**THE KENT COUNTY COUNCIL (A28 STURRY LINK ROAD)  
(COMPULSORY PURCHASE) ORDER 2023**

**THE KENT COUNTY COUNCIL (A28 STURRY LINK ROAD)  
(SIDE ROADS) ORDER 2023**

**STATEMENT OF EVIDENCE**

**SUBMITTED FOR THE PUBLIC INQUIRY**

**Figure C**  
**CPO (Compulsory Purchase Order) Map Showing Relevant Plot 4**

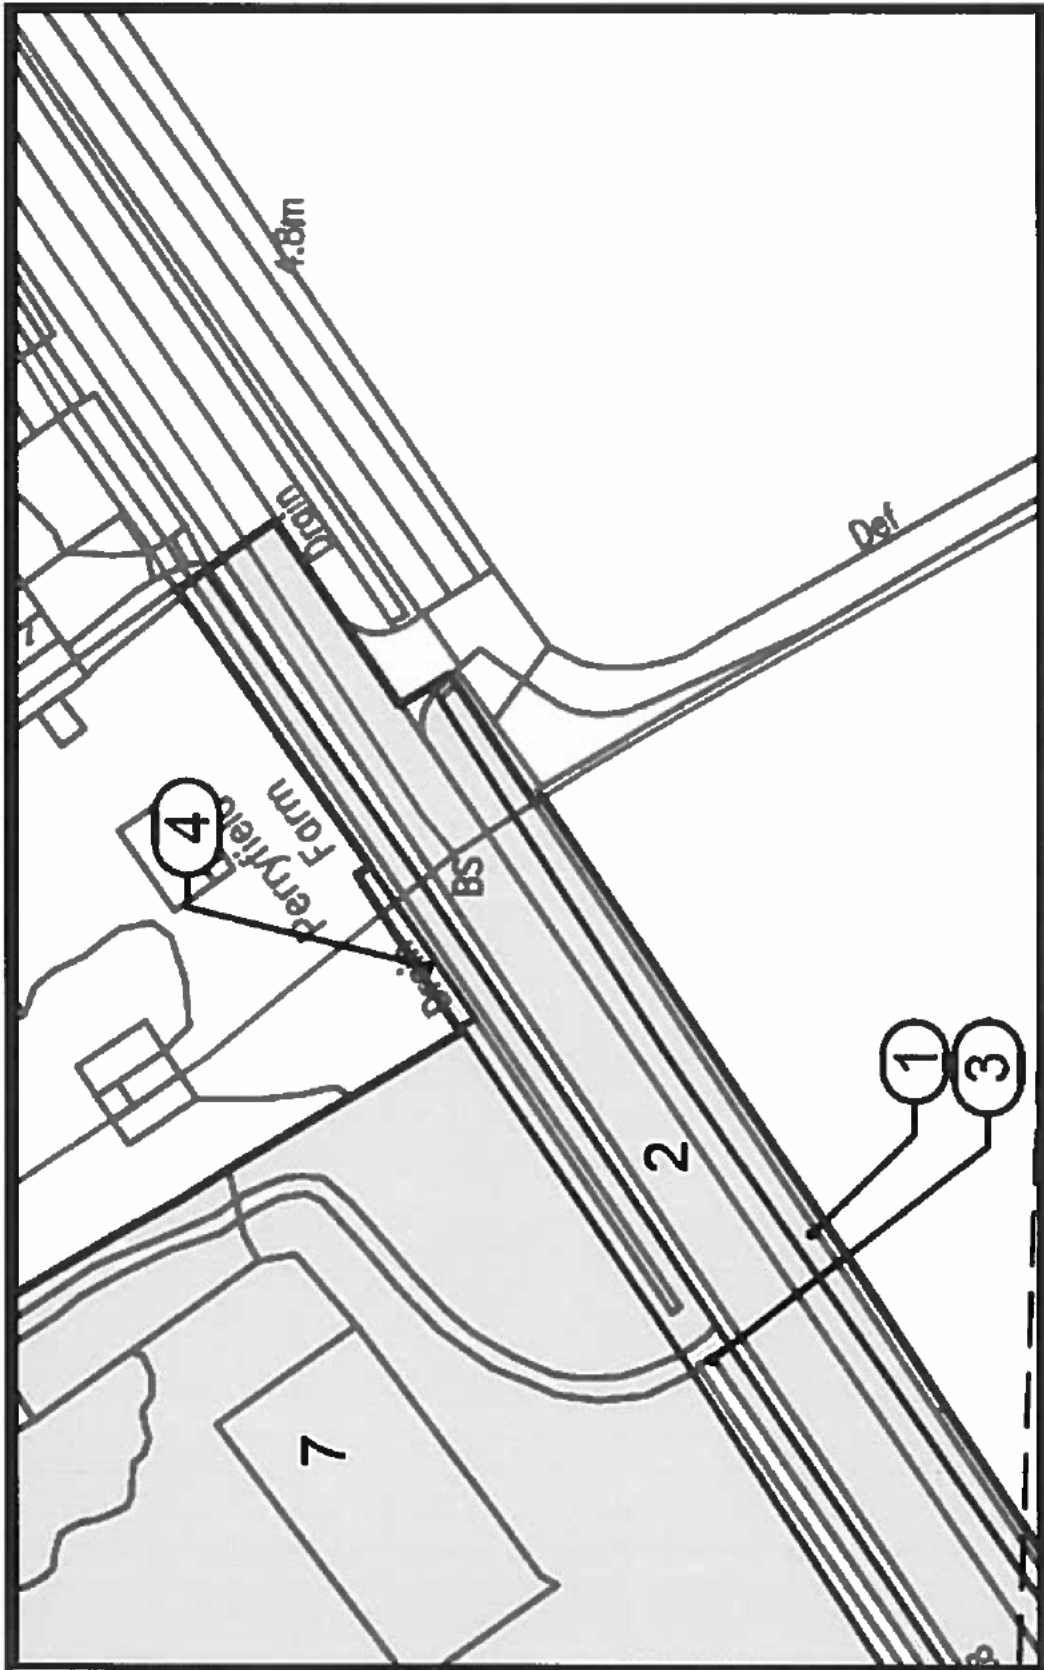
The imposition of Plot 4 on the frontage of our land is not vitally necessary. From the CPO Order Map in Fig. B, Fig. C is an enlargement showing Plot 4.

In the Statement Of Case, a fairly vague and misleading explanation is given for KCC wanting Plot 4, quote “wooded strip across the frontage of Perryfield Farm required for construction of a drainage outfall. We have specifically requested but have not been given details about this stated “drainage outfall”.

It is certainly possible to implement the roundabout and to make all necessary drainage connections to the Sturry Dyke (ditch) without any of our frontage. Such layouts had been long discussed before Plot 4 was suddenly introduced. The layout in the Overall Scheme Plan Drawing No. 4300392-000-63, see Fig. A, along with other drawings, affirms it is not necessary for KCC to acquire Plot 4.

Surface water drainage and overflow from rare occasions of extreme weather may be piped from the Attenuation Basins located to the west of our boundary. It is baffling to route this pipework from being off our land, needlessly on to our frontage, along the proposed Plot 4, to then discharge it in the Sturry Dyke. Surely the more appropriate, practical and cost effective alternative option is to route the pipework directly to the Sturry Dyke without crossing on to our land.

We recognise that there will be various works occurring along our frontage. The existing driveway and steps are to be replaced with a ramp arrangement. Also our understanding is that KCC will be responsible for various works along the Sturry Dyke ditch, inevitably incurred through their acquisition of Plot 3. However, all envisaged work can be done with ‘temporary’ access agreements. Hence ‘permanent’ acquisition or rights over Plot 4 is certainly not imperative.

It is crucial that we remain exclusive owners of the full width of our frontage, particularly in view of our long term plans for landscaping, noise and security. Currently, the ditch and level of the frontage land form a clear demarcation. Various security issues would arise if others have access to the Plot 4 land.

We strongly plead for all of KCC’S Plot 4 proposals to be rejected outright.

CPO (Compulsory Purchase Order) Map Showing Relevant Plots 11,12,14,15

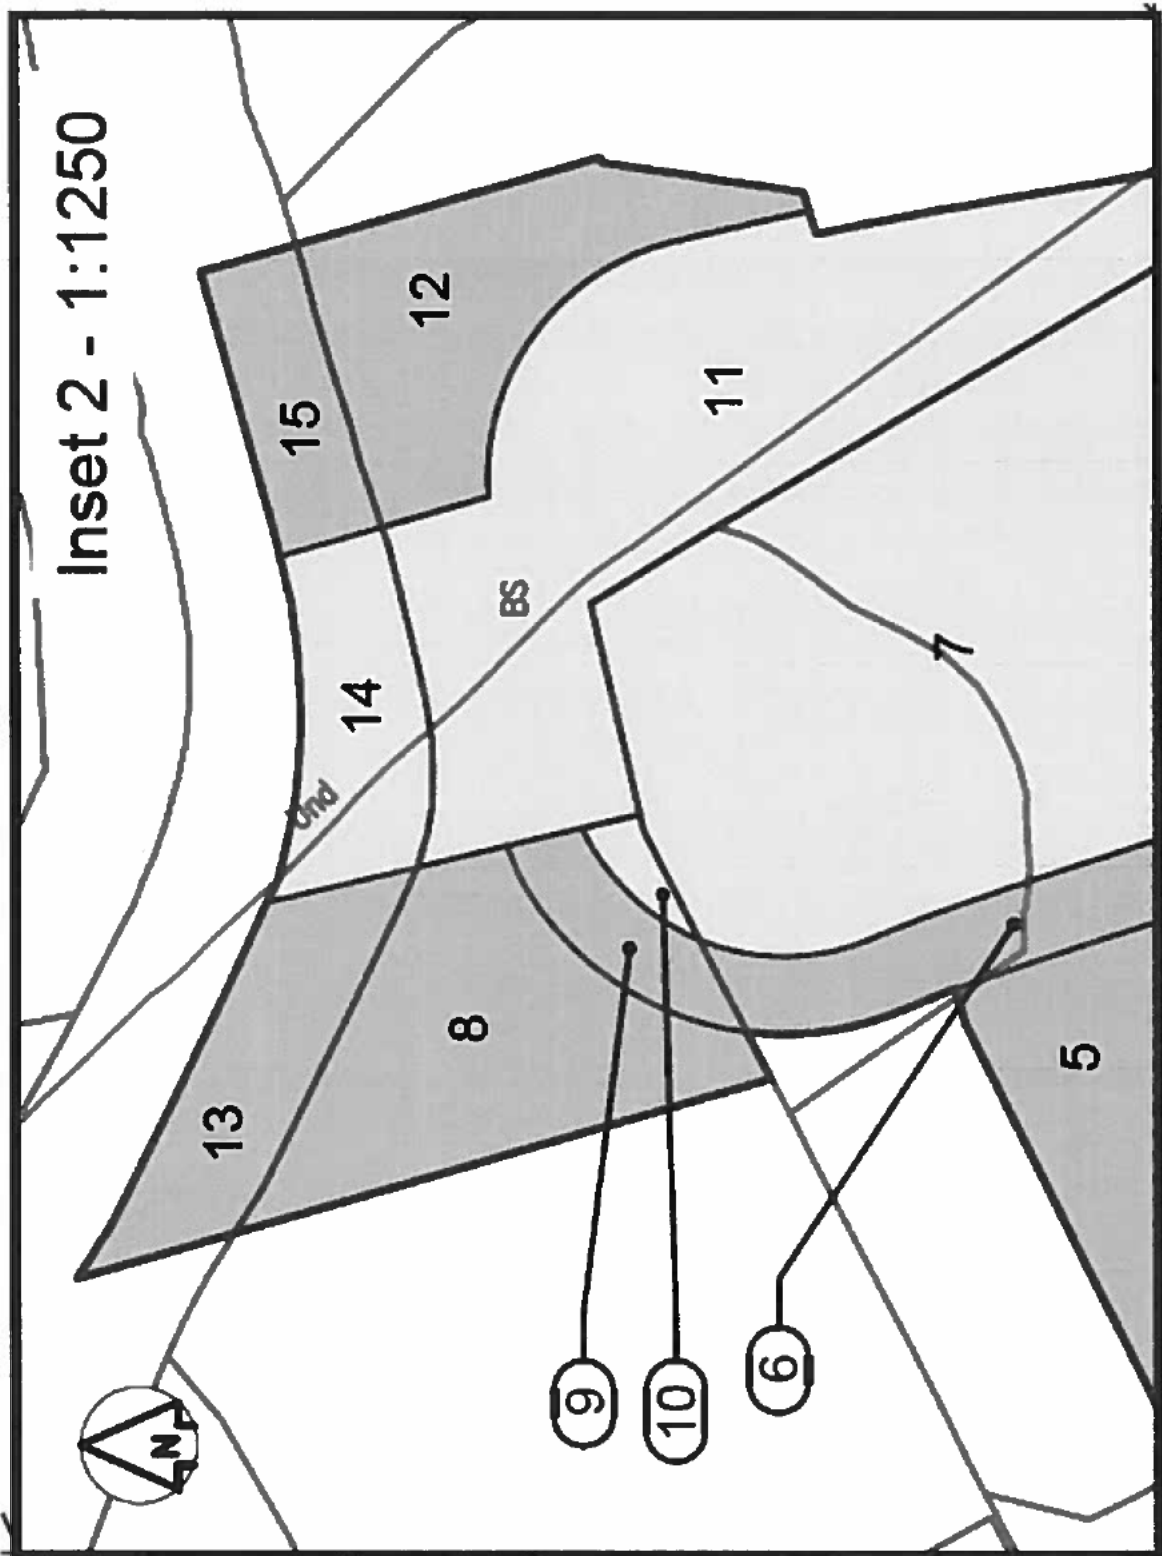
Plot 11 is shown as one area on the CPO Map, see Fig. B and D, but should be treated as several distinct areas: where the approach road goes over our land; where the viaduct pass over our land; where the embankment covers our land.

KCC specifically declare in the 'Statement Of Case', Section 8.3 on Page 24, quote "The County Council has no requirement to own land under the viaduct". However this declaration is clearly contradicted by KCC's attempted acquisition using Plot 11 with its excessively large area covering all land under the viaduct.

We object to KCC's proposal that would leave us with just a 3.5 metres strip of land bordering the river. Besides the small size, the use of this piece of land would be severely limited by proposed restrictions that KCC have mooted.

See Fig. B and D for the Plot 12 area. Quoting from the Statement Of Case, KCC require “rights over amenity land at rear land holding of Perryfield Farm for construction of the viaduct”. We do not oppose construction of the viaduct, but object to the permanent and restrictive rights that KCC demand thereafter.

Plot 12 enables part of an established paddock. It is historically affirmed by the existing stable and associated outbuildings. We object to conceding any rights over Plot 12 that can effectively restrict its possible uses now or in the future.

It is important to recognise the potential impact on the paddock that can result from land lost through both Plot 12 and Plot 11. The CPO Order Schedule gives Plot 12 as 317 square metres and Plot 11 as 900 square metres, a total of 1217. This amount of land loss would effectively reduce the paddock to being useless, making it smaller than what is required for a horse. This highlights one reason for our need to ensure minimal land take and restrictions with Plots 12 and 11.

Plot 12 also enables our access to the river. Our riverside land is important, particularly for memorial reasons, so it is disconcerting for it to be impacted. Note, when coupled with the proposed acquisition of Plot 11, there would be effective restrictions imposed on us using our full stretch of riverside land.

It is appropriate to expose that permanent rights over Plot 12 is not essential. Refer to the representative viaduct Drawing No. 4300392/1700/ID/01, Fig. G. The initial construction may require lengthy steel girders to span the 42 metre distances between supporting piers. However, after construction, there will be little need for moving or storing large parts, hence no vital need to use Plot 12. Also, with Plot 8 agreed, it would always be available for use in place of Plot 12.

Refer to Fig. B and D. We own the land bordering this stretch of the river. Hence, by default, it makes us the owner of the river up to the half width point, regardless of whether the title is specifically registered. We trust there will not be a contentious rush to a 'land grab', or literally a 'river grab'.

Subsequently the requirement has been re-designated to "permanent rights", implicitly for inspecting the viaduct's underside. As quoted below for Plot 15, inspections will be done by lowering a gantry from the road above the viaduct. This can be done from the west side of the road, with the gantry over Plot 13. Consequently there is no vital need for permanent use or rights with Plot 14.

KCC specifically state requiring "permanent rights" over the Plot 15 river area, quote, "to lower a gantry from the Link Road to inspect the underside of the viaduct deck". Obviously, a gantry can be similarly lowered from the west side of the Link Road, over the Plot 13 river area. Hence, with rights over Plot 13, there is no vital need for KCC to agitate for "permanent rights" over Plot 15.

We respectfully request that, first, KCC re-submit updated drawings for Plot 11. It is needed, in any case, due to KCC's change from aiming to acquire all land to now wanting just some of our land under the viaduct. The drawings should distinctly show relevant features such as roadway, walkway, embankment, etc.

Figure F

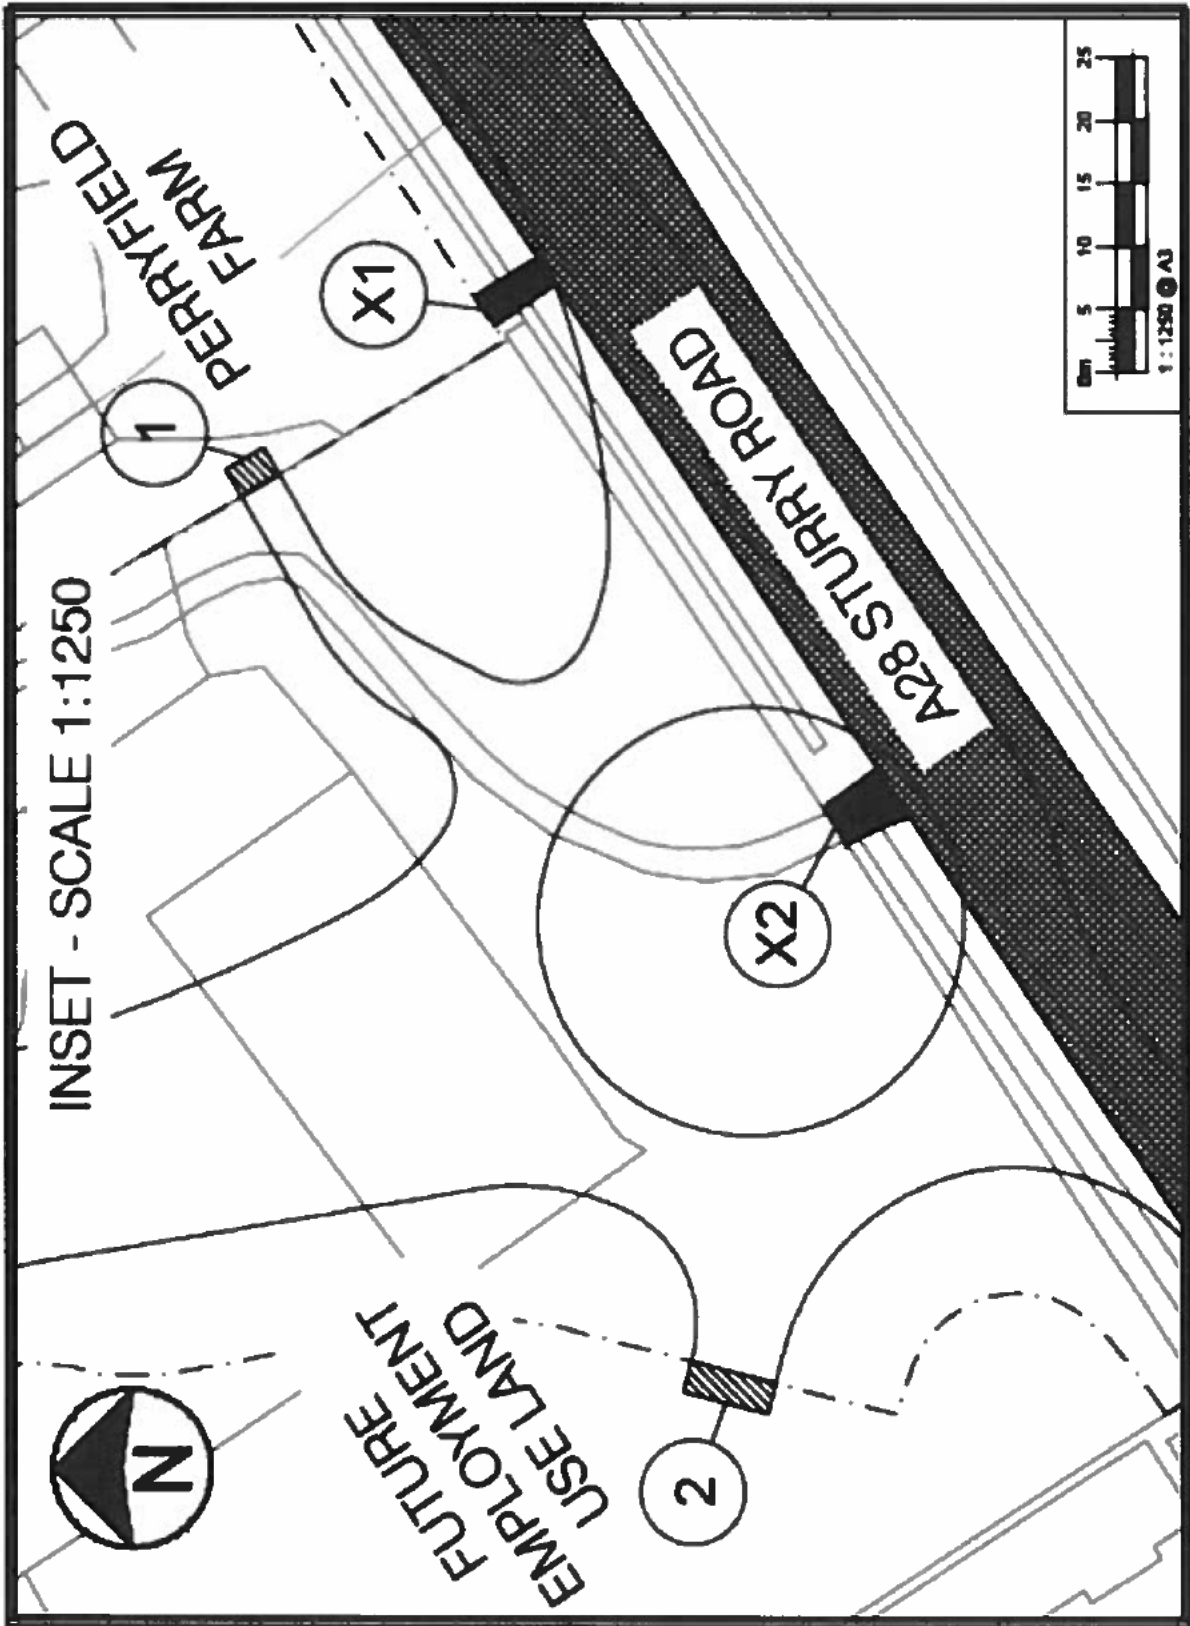
Also refer to the more up-to-date and currently submitted Side Roads Order Drawing No. 008469-PCL-LSI-ZZ-DR-CH-0001, Fig. E. Fig. F is an enlarged part. It further affirms that Plot 4 is not vitally needed to implement the roundabout.

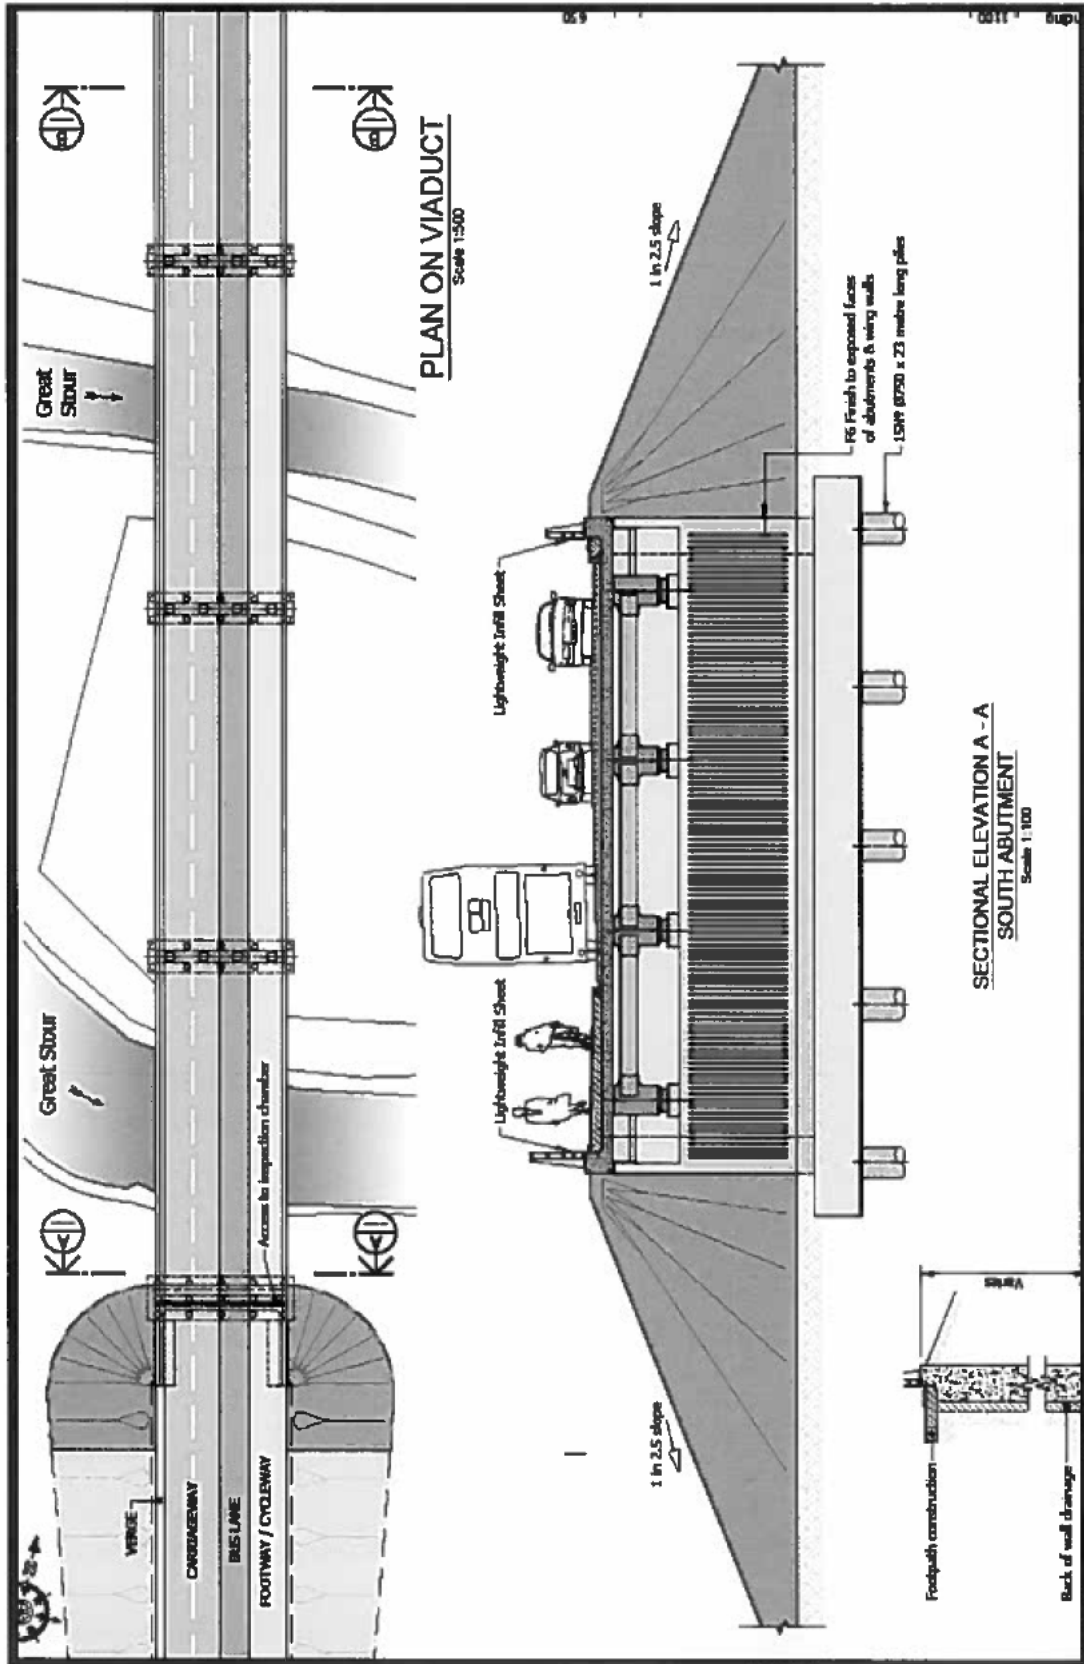
KCC now aim to acquire land under the viaduct extending 4.5 metres from the viaduct's abutment (i.e. 4.5 metres from the A-A line in Fig. H). The area of the foundations is given as a main reason for acquiring more land than needed. Fig. I indicates that less than a metre, not 4.5 metres, could realistically suffice.

One adverse consequence of a 2.5:1 ratio slope is that the embankment then extends out more, see Fig. J, resulting in more land being taken unnecessarily. This specifically impacts us with regards to the proposed Plot 11 area.

Also, referring to Fig. J reveals how undesirable persons can easily stroll down the embankment. It facilitates unacceptable activities underneath the viaduct. It also facilitates easy access to all of our land, outbuildings and house. Notably the wood fencing KCC suggests can be easily knocked through and breached.
